ECE/TRANS/WP.29/GRPE/2009/7  
31 October 2008

**AMENDMENTS TO UNECE REGULATIONS**

Regulation No. 83

Proposal for draft amendments to Regulation No. 83

**Figure 8/2:** Parameters measured during emissions test during and between cycles where regeneration occurs (schematic example)

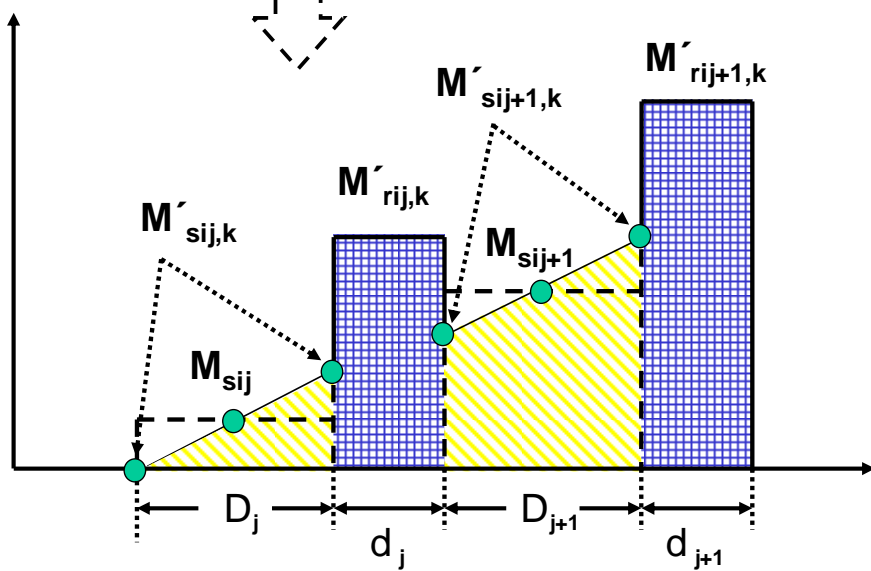
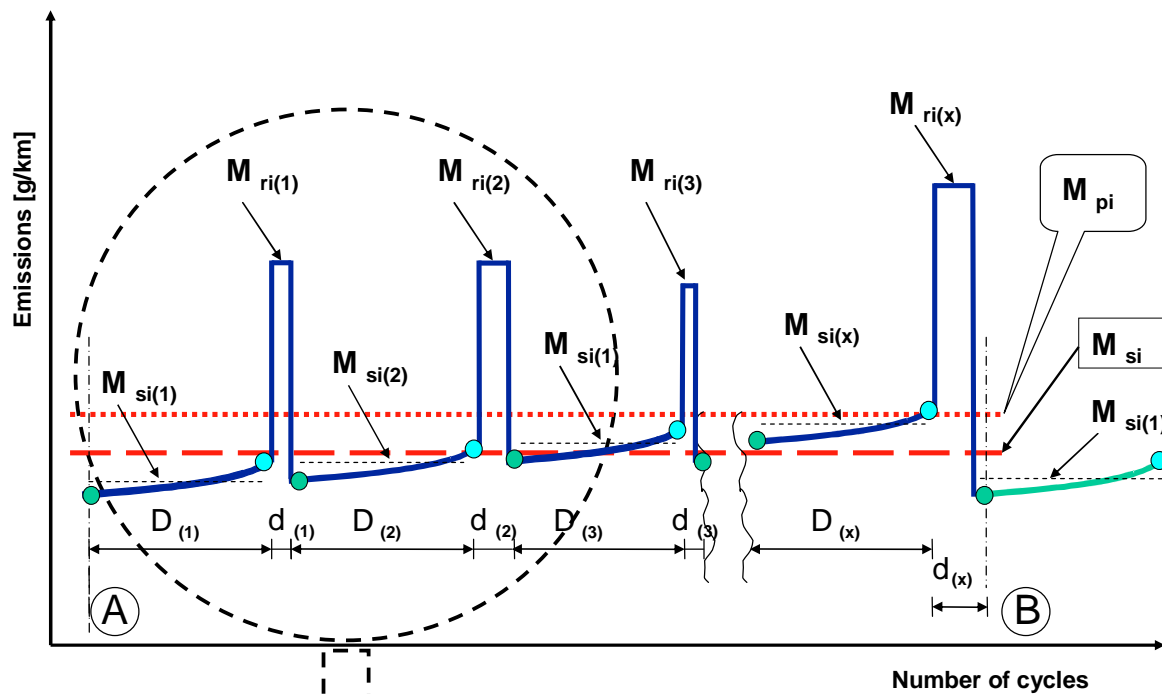
**3.4. Calculation of combined exhaust emissions of multiple periodic regenerating systems**

For exemplary illustration of measurement parameters see Figure 8/2.

The calculation of the factor (K<sub>i</sub>) for multiple periodic regenerating systems is only possible after a certain number of regeneration phases for each system. After performing the complete procedure (A to B, see Figure 8/2), the original starting conditions A should be reached again.
